Urgent Field Safety Notice

Medtronic StrataMR™ Adjustable Valves & Shunts

Model numbers 42955, 42965, 45905, 46955, 46960, 46965, and 46970
Recall

Medtronic reference: FA759

Figure 1
Example of a **Correct** rotor
orientation

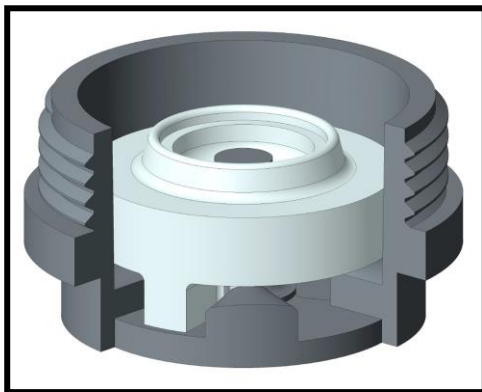
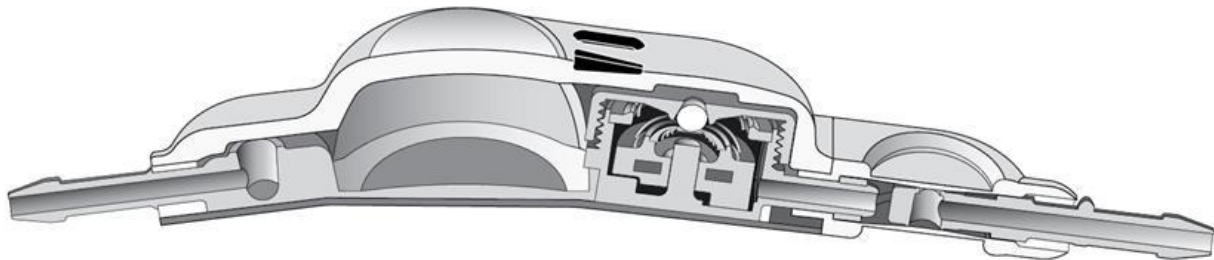
You are receiving this letter because you may have received one or more of the affected products. Medtronic is initiating this voluntary recall because the products identified above may experience a condition that may, in limited circumstances, affect the flow resistance in the valve and result in underdrainage of cerebrospinal fluid (CSF). The condition can occur when the valve mechanism is adjusted to a position that causes a higher than intended flow resistance. This higher than intended flow resistance is a result of the MRI Resistance Key on the bottom of the valve's rotor mechanism being placed on top of one of the MRI Resistance Walls, instead of in one of the pressure setting wells (see **Figures 1 & 2**). This condition only occurs during the valve adjustment process.

As part of the adjustment process of the StrataMR Adjustable Valve system, it is important to note that if the valve's pressure flow setting is accurately aligned and centered via proper technique as described in the IFU (also see Figure 3 and the instructions in Addendum A), the valve MRI Resistance Key will be set to the correct pressure setting well.

Figure 2
Example of an **Incorrect** rotor
orientation

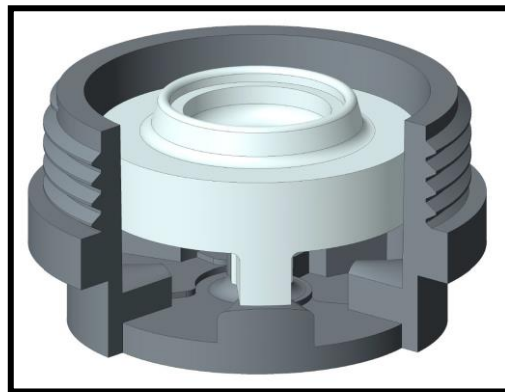
When the StrataMR™ valve is set in an orientation as seen in Figure 2, pressure flow performance approximately twice the level above StrataMR's highest Performance Level setting of 2.5, can occur and lead to cerebrospinal fluid (CSF) underdrainage. This condition may result in the following adverse health consequences: headaches, nausea, vomiting and lethargy. If left untreated underdrainage has the potential to lead to coma and death.

The incorrect valve rotor orientation (Figure 2) can be caused by misalignment and/or off-center positioning of the StrataMR™ Locator Tool, relative to the valve mechanism.

Figure 3
Correct
Good Alignment and Centering
of Locator Tool and Valve Mechanism

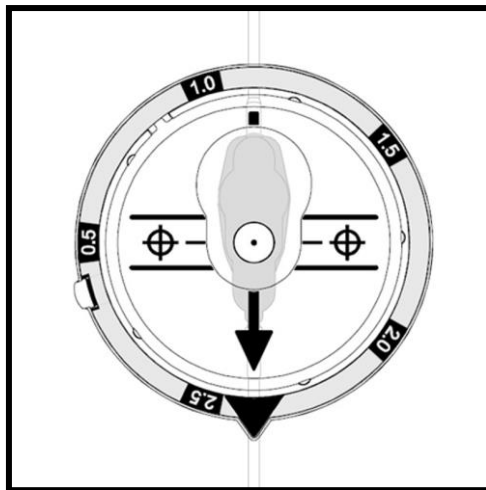
Figure 3 provides an example of proper/correct technique. Figures 4, 5, & 6 provide examples of incorrect alignment and centering techniques that should be avoided.
